DESCRIPTIVE REPORT

Type of Survey Field Examination

Registery No. FE-298

General Locality Sitka

ALASKA, SOUTHEAST COAST
SITKA HARBOR, CRESCENT BAY MARINA

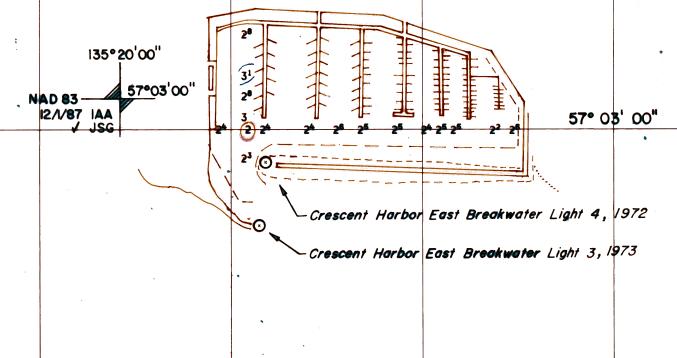
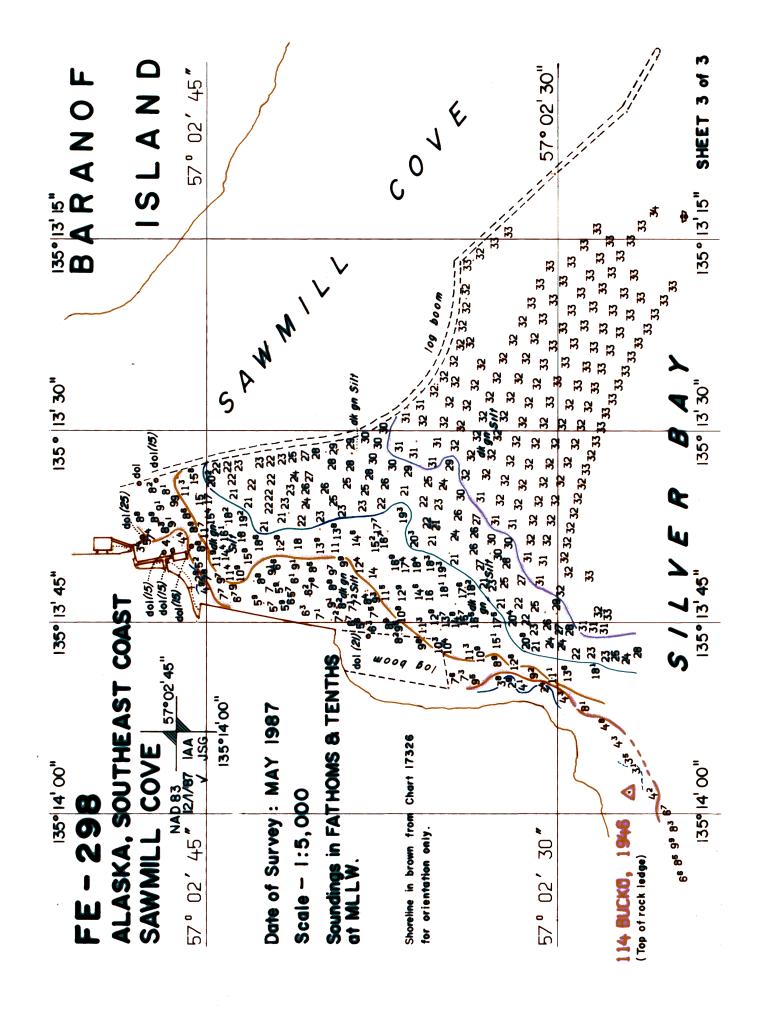
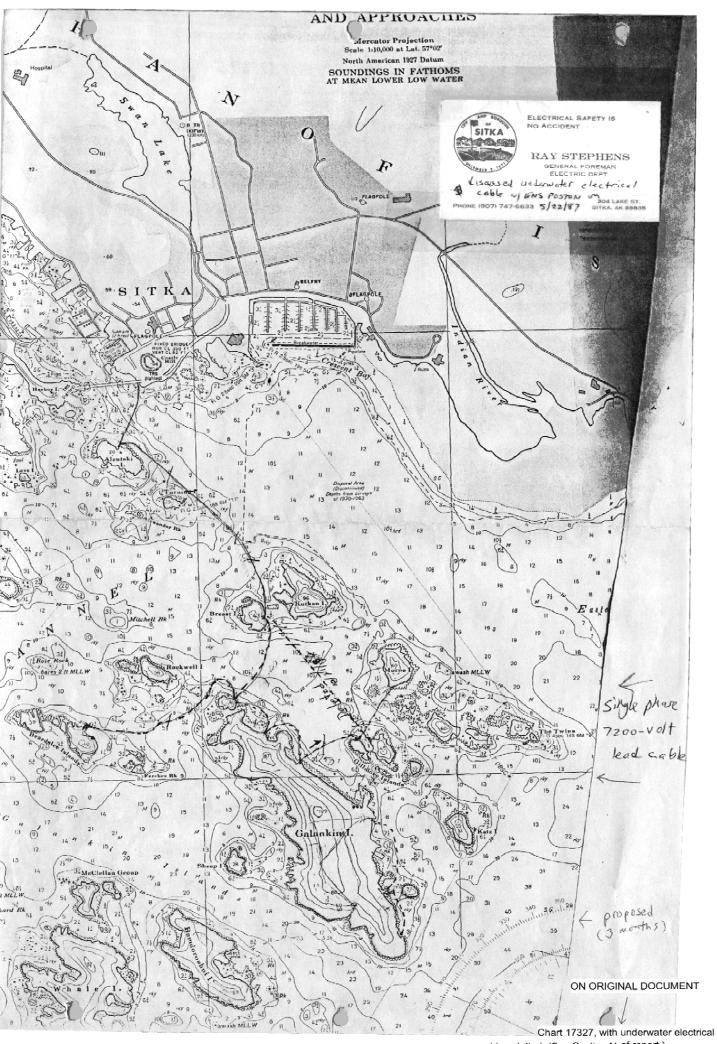
The hydrographer determined least depths of 3.5fm and 4.1fm for two rocks within the area of AWOIS #51078 (Sitka Harbor). The least depths do not appear on the final field sheet. The least depths of all investigations should be included on the final field sheets [HM 1.5.2, 4.5.7.2; PMC OPORDER Section 3.5.1.a.2.(b).(2)].

One five-fathom depth curve was omitted on the final field sheet in Sitka Harbor (see Attachment A).

Inconsistencies exist between the Sitka Harbor final field sheet and the soundings designated "NSP" in the Abstract of Positions (Appendix VII of Descriptive Report). The Abstract of Positions should accurately reflect the soundings on the final field sheet [PMC OPORDER Section 3.5.1.d.1.(a)].

The hydrographer recommends deleting four charted slips; the final field sheet shows only three slips were deleted (see Attachment B).

Five dolphins were noted in the data printouts but no heights were determined. Elevations of dolphins should be determined so the feature will be correctly depicted on the smooth sheet [HSG 35, "Source Cartographic Codes and Symbols", Table B-3, Part 2].
